Brookhaven National Laboratory
Plant Engineering - E&CS Division
Engineering Change Notice Form

PROJECT: CCWF II

ECN Title: Bldg 600C Stairs

ECN No. 59

SIDE ELEVATION

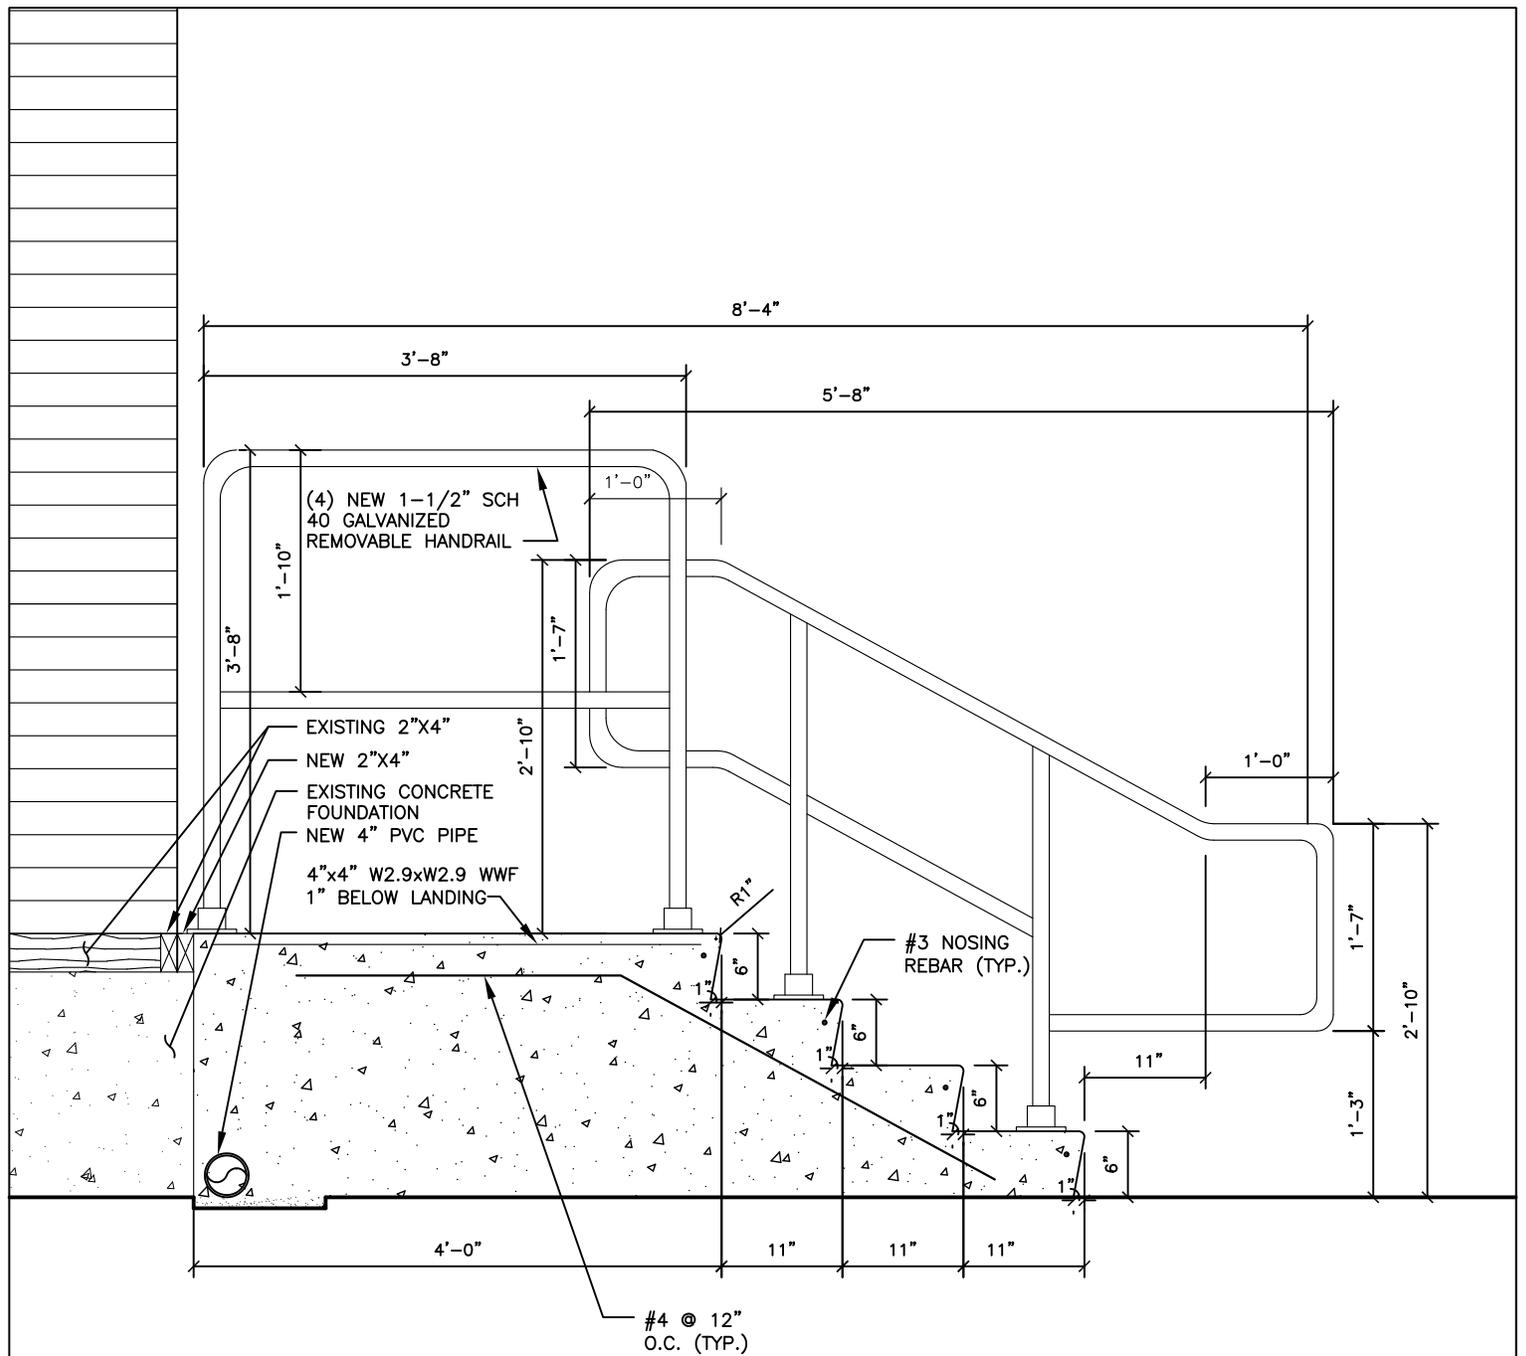
Requested Change (Attach sketch if applicable): Adding Stairs and railing to the front of bldg 600C

NOTES:
 1. 4,000 PSI CONCRETE @ 28 DAYS
 2. BROOM FINISH
